Wingra West Watershed Study Solutions

by City of Madison Engineering Division
April 26, 2022

Public Comments on the Wingra West Report

Comments pertaining to the Odana Pond Complex

Pond Complex Schematic: Proposed Conditions

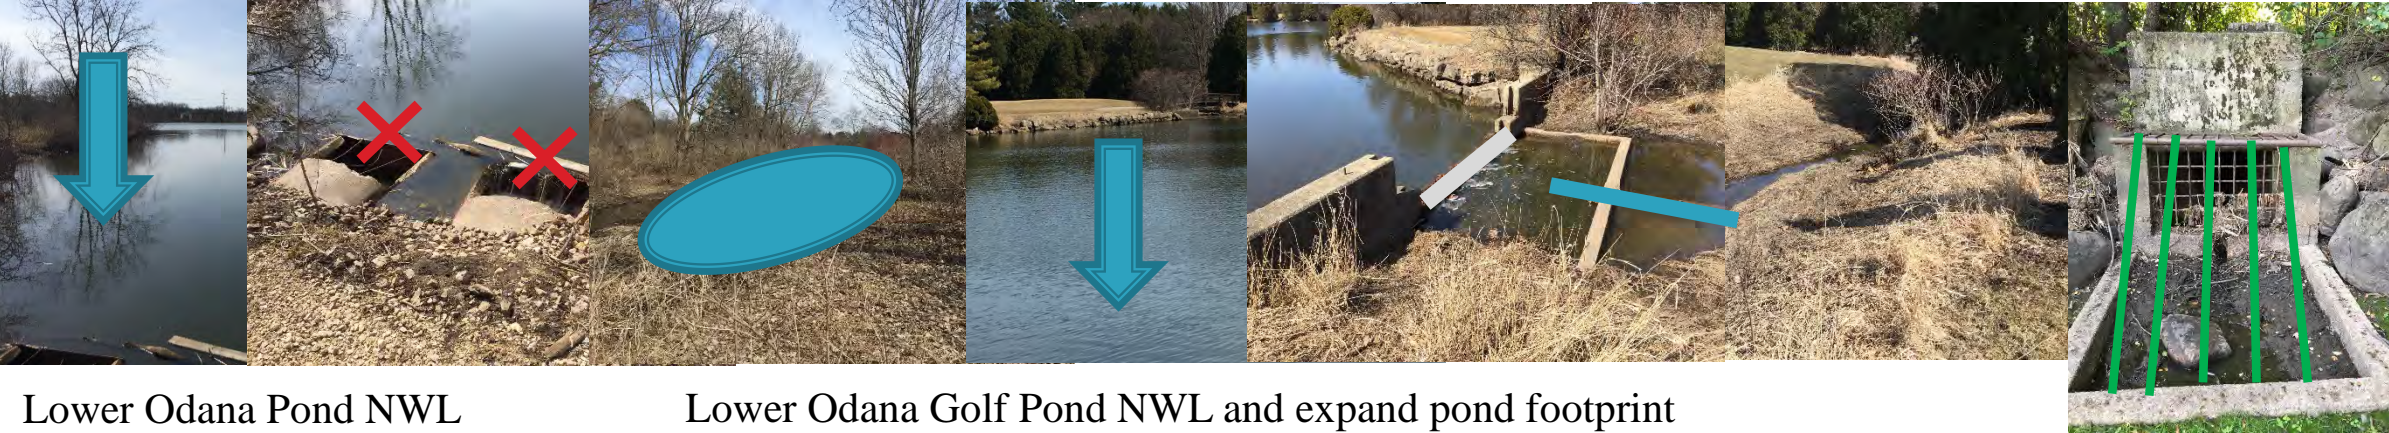
Why expand the footprint of the ponds instead of the depth?

- ▶ Lowering the normal water level of the ponds is providing more storage without increasing the footprint of the pond.
- ▶ Digging a pond deeper and then holding water in the new deeper pond does not help with managing peak flow rates. Schematic added to comment section to show the modifications.

Figure 10-11: Odana Hills Golf Course Detention Basin Expansion

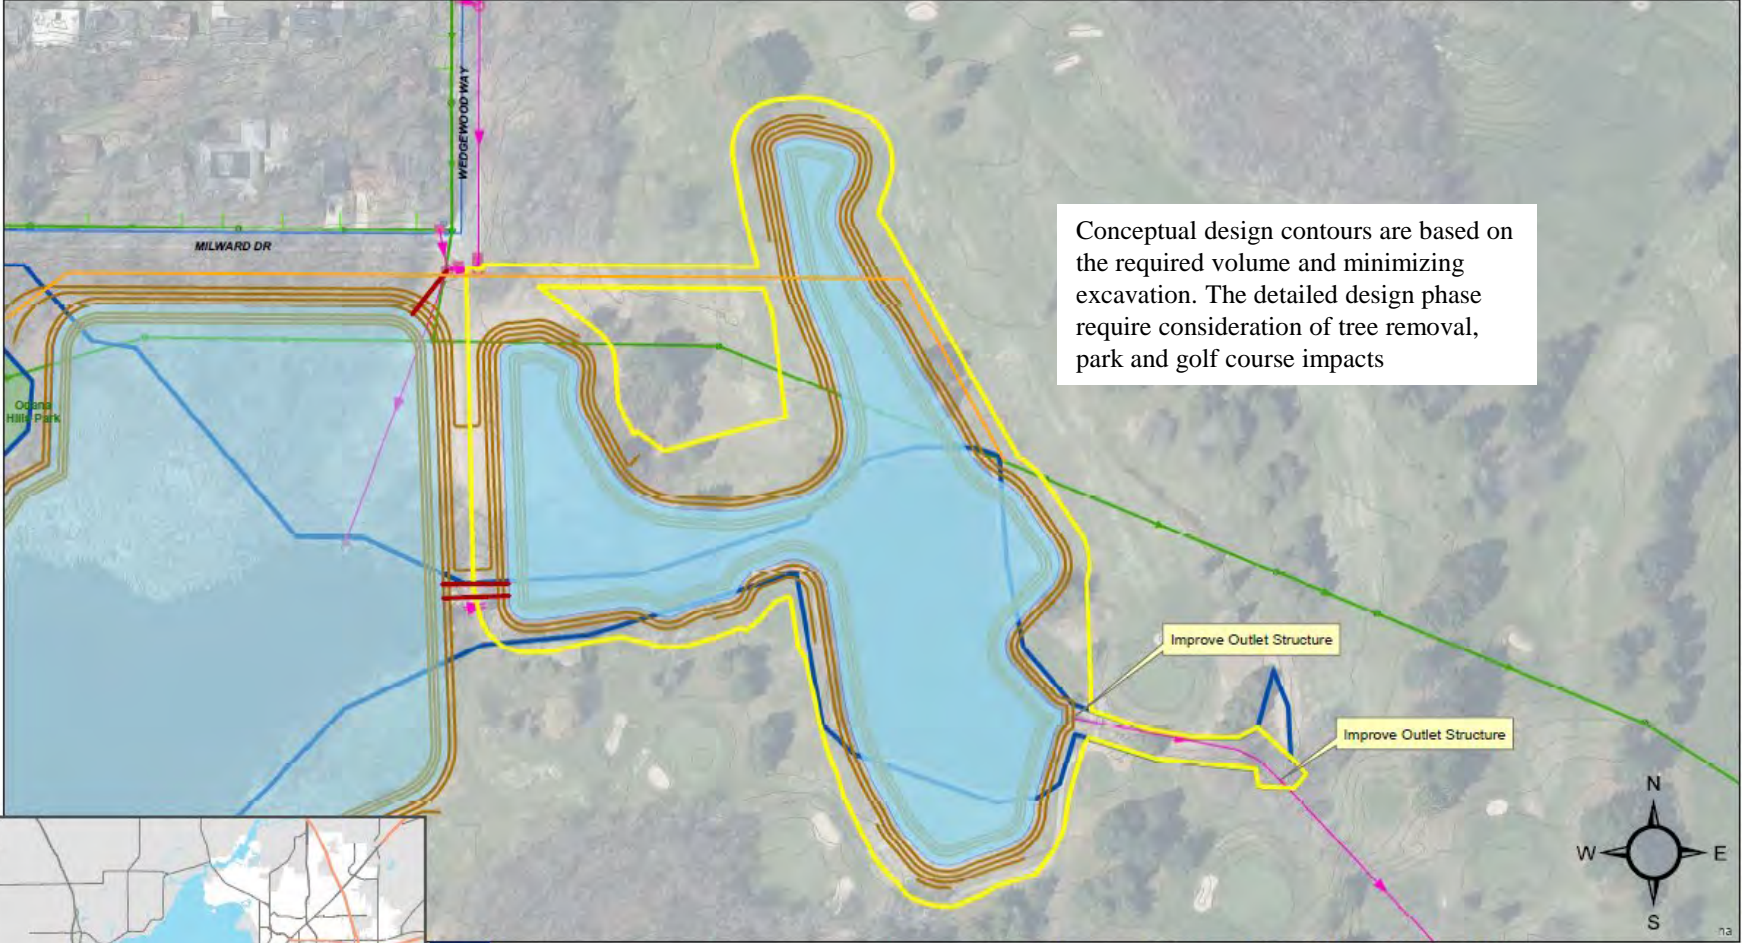
Expanding the ponds to the north will impact the forested area. What are the plans for replanting, noise mitigation and cross country ski connectivity

- ▶ The proposed solutions are at a pretty high level and really intended to be a guide at this level.
- ▶ As the proposed solutions move towards implementation phase additional detail will go into the design. The loss of high quality trees , Noise mitigation and ski connectivity would definitely need to be addressed/ mitigated.
- ▶ pond contours changed to avoid impacting as many trees.
